*“City of Havelock,
2023 Storm Water Drain Pipe Replacement
Hillcrest St. Havelock, NC. 28532”*

Addendum 1

Questions Received

Figure 1: Map of the Cities Utilities on Hillcrest St.

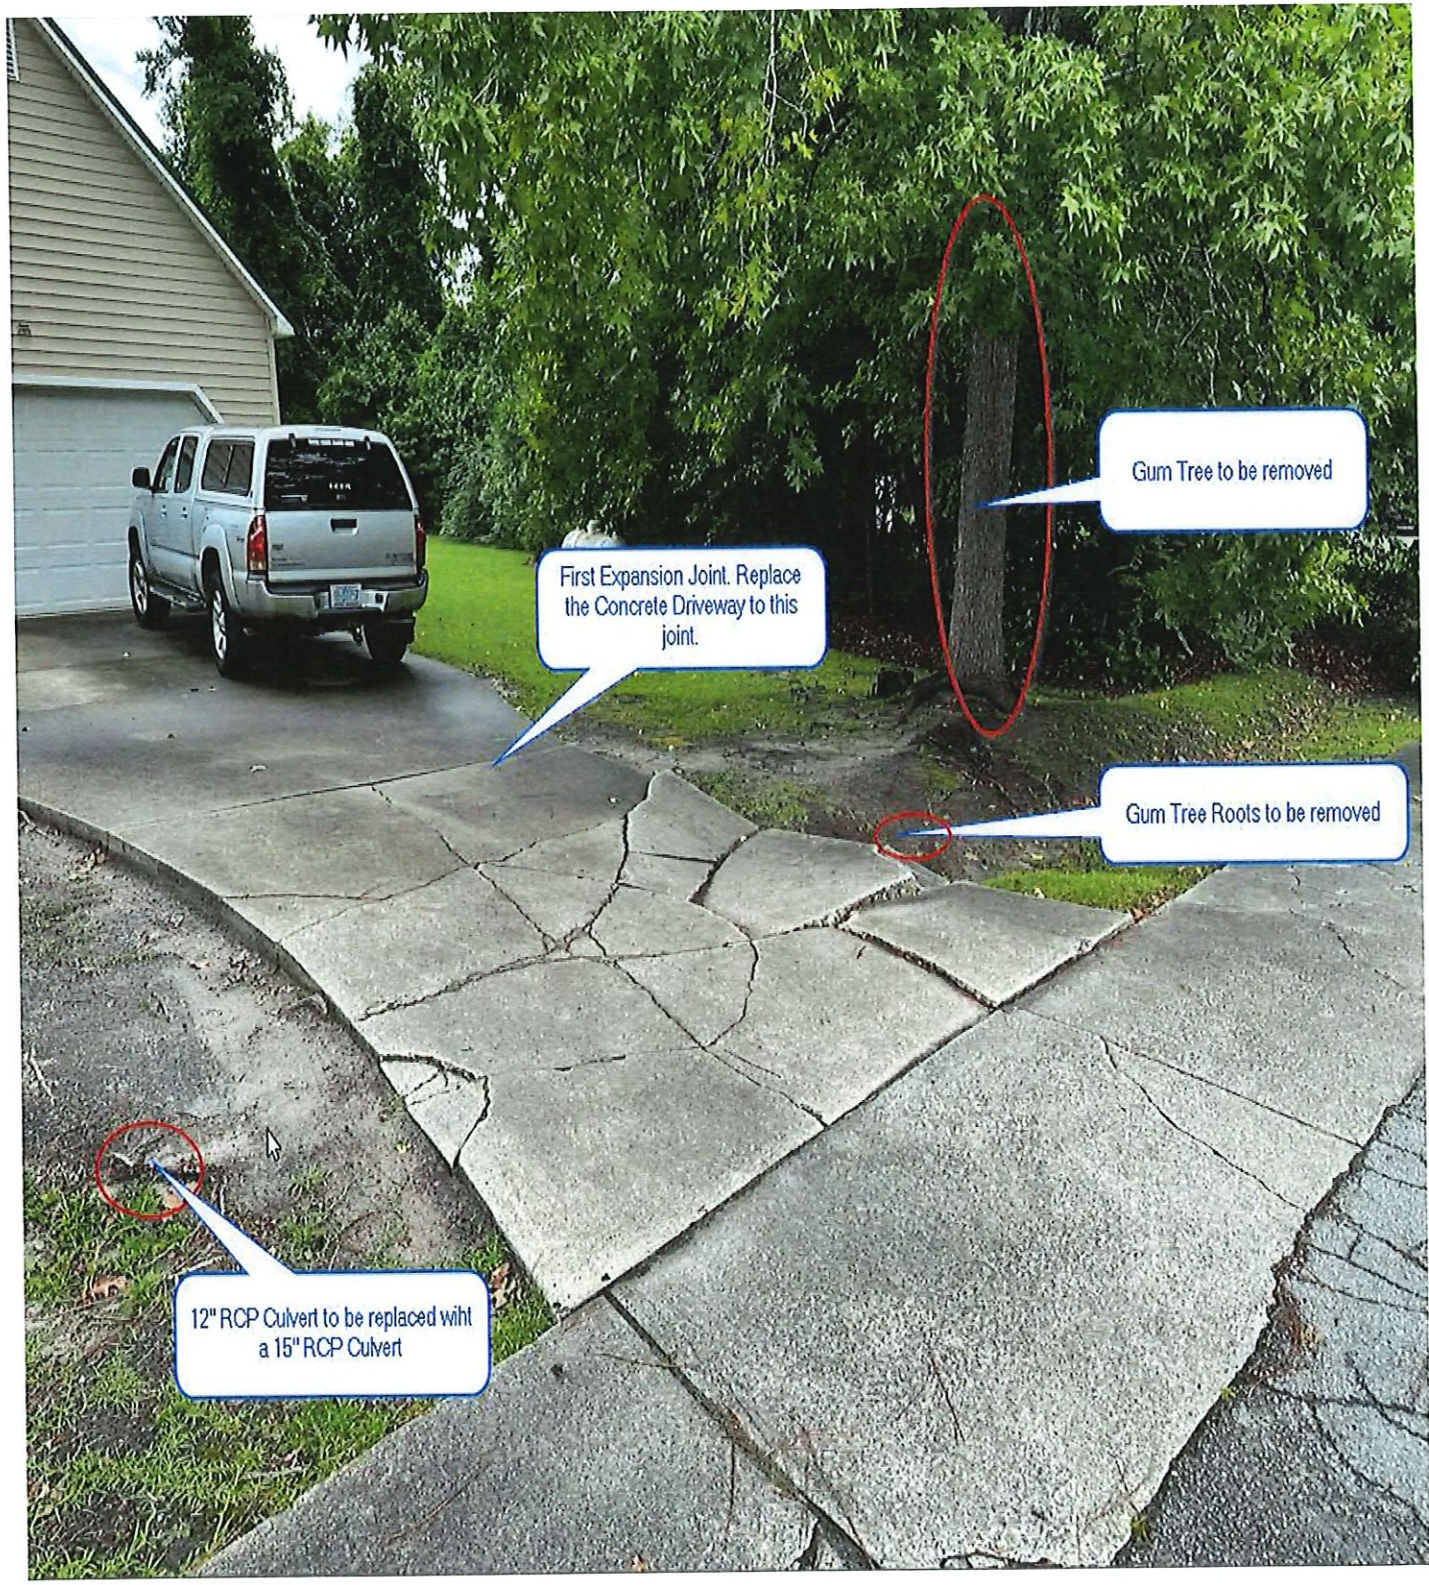
1. I am writing to express a concern regarding the sewer and water lines crossing within six inches, as evidenced in the bids attached photo. There appears to be a 90-degree bend directly beneath your pipe that we would need to restrain, which could potentially lead to complex issues. The age of this pipe is also uncertain, which further complicates matters. Could you please provide further information or instruction on how to proceed with this issue to ensure we're addressing it appropriately?

Locates should be performed prior to excavating. The contractor should take caution when excavating the area, test pitting of the area is recommended. Any damage to existing utilities will be the responsibility of the contractor to repair.
